**Subject: Southern California Edison’s Control-Silver Peak Project (A.21-08-009) –  
Data Request No. 2**

**Data Request No. 2 (August 30, 2024) for SCE's Control Silver Peak Project (A.21-08-009)**

**Exhibit A**  
**Proposed Hwy 6 Alternative KOPs**

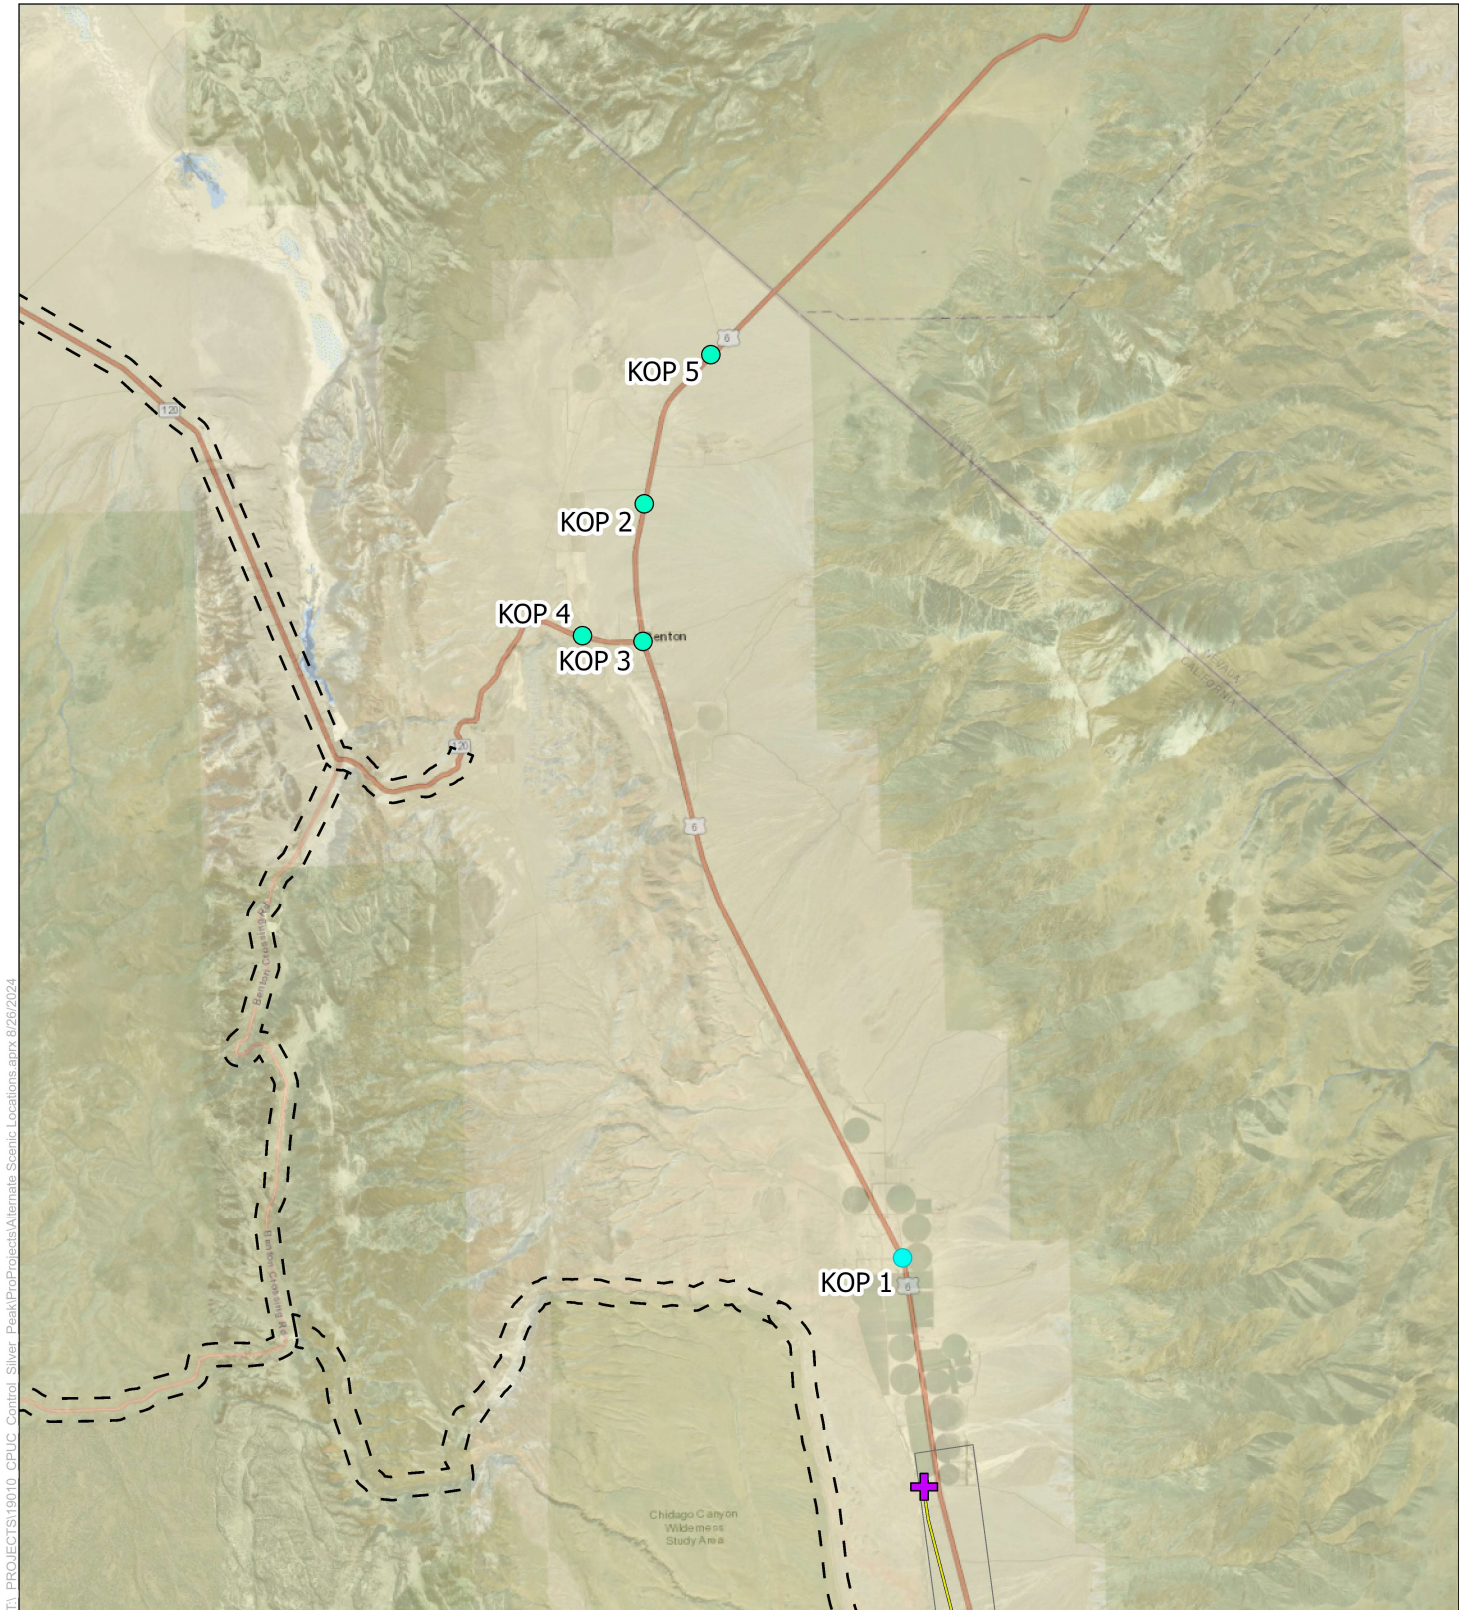
3	Alternatives – Highway 6 Alternative – Aesthetics	N/A	<p><b>Additional KOPs/Simulations</b></p> <p>Please obtain additional key observation point (KOP) photos for the locations shown in the attached map (Exhibit A). Prepare visual simulations showing the anticipated features (subtransmission poles, lines) from these additional KOPs. Note that the locations are approximate – capture the KOP photos based on the detailed alternative information (e.g., specific pole/alignment locations) such as to reflect the maximum impact on aesthetics and public views. Additionally, to the extent higher voltage facilities (e.g., 115 kV) would be substantially taller/larger than the 55 kV facilities proposed under the Proposed Project, please provide updated visual simulations for KOPs along Segment 3. For example, please provide updated simulations for KOPs 3-1, 3-2, 3-4, 3-5, 3-6, 3-11, 3-12, 3-16, and 3-19, as designated in the POD materials.</p>
